Access Compliance Report

Public Rights-of-Way

(Curb Ramps)

Intersection ID: 7771	Main Street: SENIOR_DR	Cross Street: TWINFIELD_DR	Location:	N
ADA ID: FB305F29DFBE	Ramp Type: BlendTrans1	Initial Pass/Fail: Pass	Overall Compliance: No	Severity Score: 9.25
Codes/Mitigation Info/Possible Solution		Field Measurements/Component Compliance

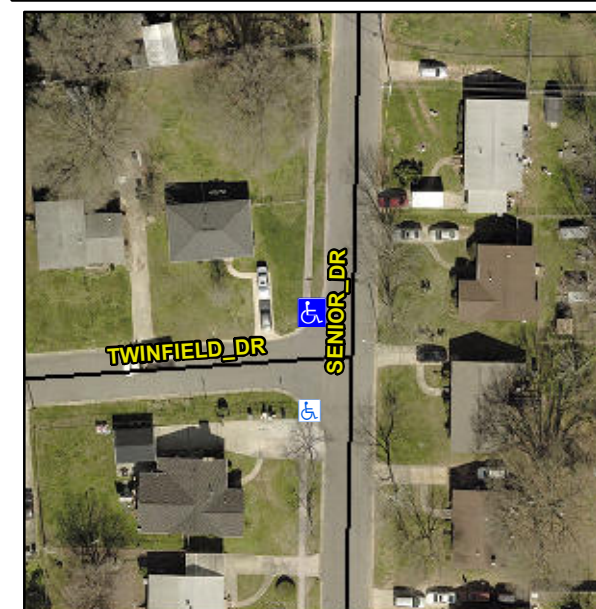
Not Found, R304.5.3, R304.2.1, R304.2.2-Perp, R304.3.2-Para, R304.5.4

Compliance	Description	Data	Compliance	Description	Data
N/A	Ramp Length (in)	150.0	Yes	BlendTrans Slope (%)	2.0
Yes	Ramp Width (in)	48.0	No	BlendTrans XSlope (%)	3.7
N/A	Flare Type LT	Sloped	N/A	Flare Type RT	Sloped
N/A	Flare Slope LT (%)	0.9	N/A	Flare Slope RT (%)	3.8
N/A	Flare Traversable LT?	No	N/A	Flare Traversable RT?	No
No	Landing Length (in)	36.0	Yes	DWS Provided?	Yes
No	Landing Width (in)	25.0	Yes	DWS Contrast?	Yes
No	Landing Slope (%)	2.3	Yes	DWS Length (in)	24.0
No	Landing X Slope (%)	2.2	Yes	DWS Full Width?	Yes
N/A	Landing Curb? (Y/N)	No	Yes	DWS Offset (in)	0.0
N/A	Shared Landing?	No			
Yes	Gutter Ponding?	No	No	Gutter Slope (%)	7.4
Yes	Gutter Lip Ht (in)	0.0	No	Gutter X Slope (%)	7.2
N/A	Painted X Walk1?	No	N/A	Painted X Walk2?	N/A
	X Walk 1 Direction	To S		X Walk 2 Direction	N/A
	X Walk 1 Width (in)	N/A		X Walk 2 Width (in)	N/A
	X Walk 1 Slope (%)	3.7		X Walk 2 Slope (%)	N/A
	X Walk 1 X Slope (%)	2.0		X Walk 2 X Slope (%)	N/A

N/A	Ramp inside XWalk1?	N/A	N/A	Ramp inside XWalk2?	N/A
	Road Slope (%)	2.0		Clear Space?	Yes
	Road X Slope (%)	3.7	N/A	Clear Space to XWalk (in)	N/A
Yes	Any Obstructions?	No	Yes	Storm Grate/Utility Hazard?	No
	Obstruction Type			Storm Grate/Utility Type	
		N/A			N/A
			Yes	Surface Condition? (G/P)	Good
			No	Curb Slope (%)	33.0

Remove & Replace Curb Ramp With Two New Directional Ramps or Equivalent. Remove & Replace Gutter.
